#### REMARKS

09/401,495

In re MARCHOLL, et al.

Fig. 1

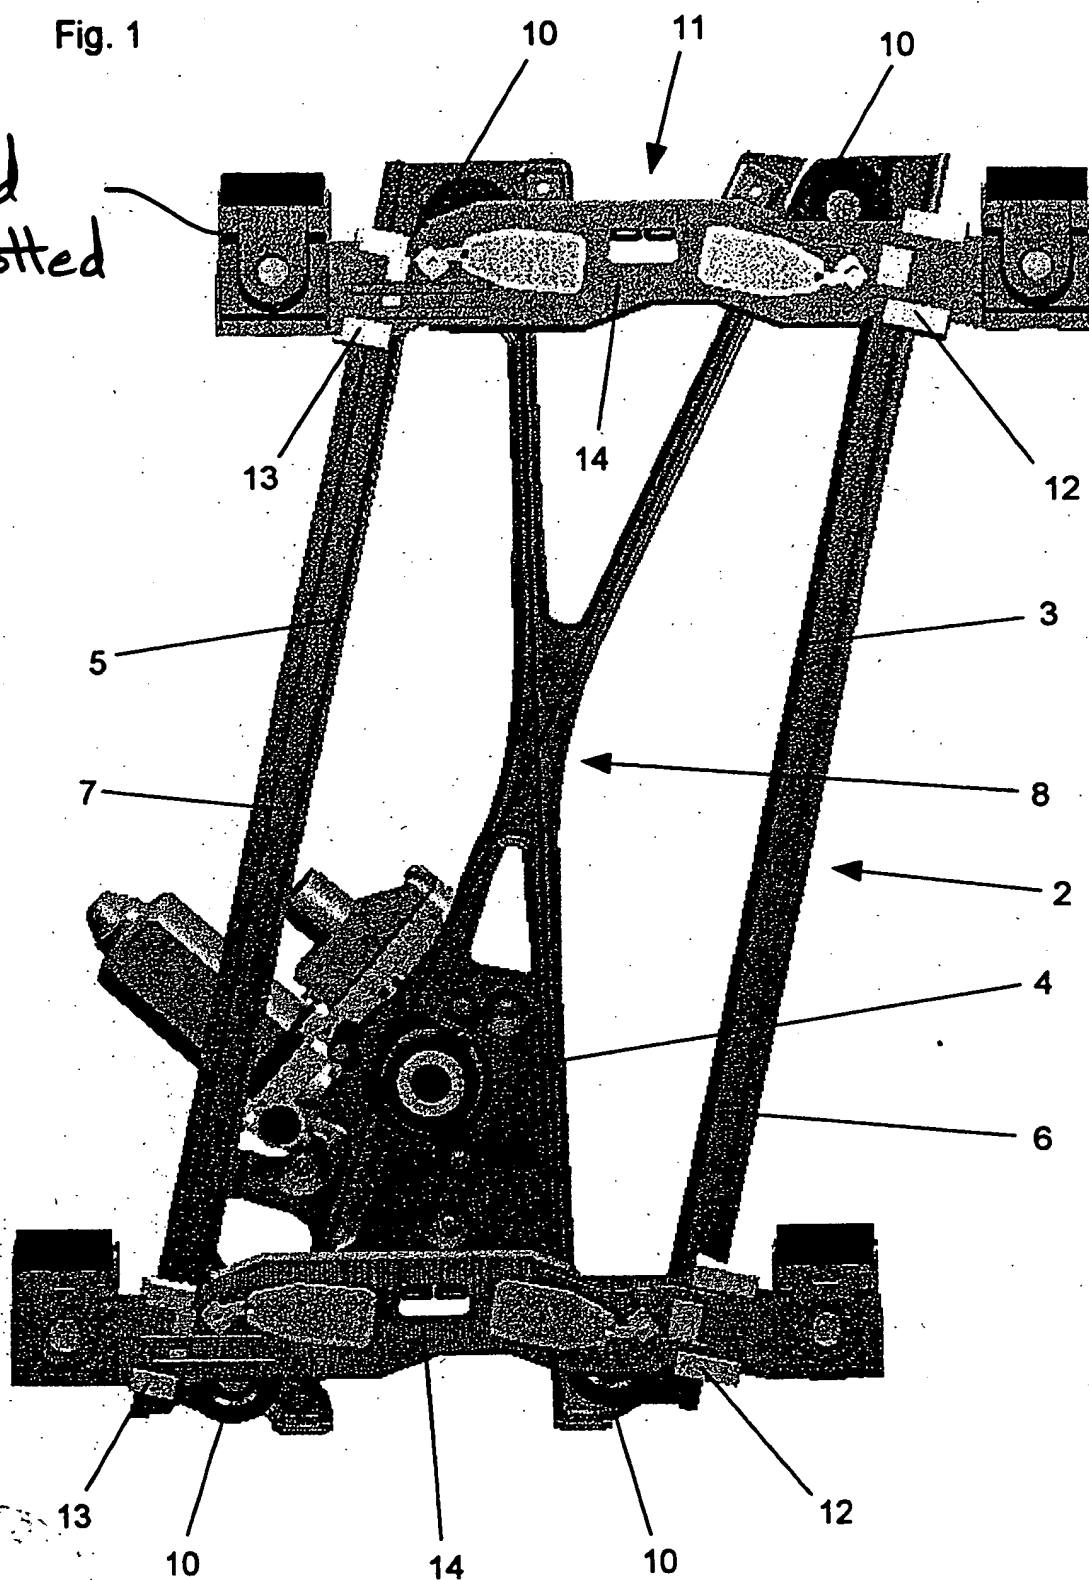
The drawings were objected to because the figures do not clear show the crossbar 14 (two crossbars 14 shown in Figure 1). It is noted that only one crossbar 14 is present in this invention. Original figure 1 merely shows the same crossbar 14 in two different positions. In addition, the Examiner objected to the use of the same reference numeral to denote different components. Lastly, the drawings were objected to for failing to illustrate the subject matter of claim 5.

corrected  
+ be dotted  
lines

Applicant has submitted a separate Letter to the Draftsperson requesting approval of several drawing correction intended to overcome these objections. Specifically, Figure 1 has been corrected (replaced) to show the crossbar 14 in dotted lines at the upper position. Figure 2 has been corrected to illustrate the limitations of original claim 5. In addition, Figures 2 and 3 have been amended to denote the reference numerals of Figure 2 with a single prime or dash (e.g., 10') and the reference numerals of Figure 3 with a double prime or dash (e.g., 10''). The corresponding reference numerals in the specification have been amended accordingly. No new matter has been entered.
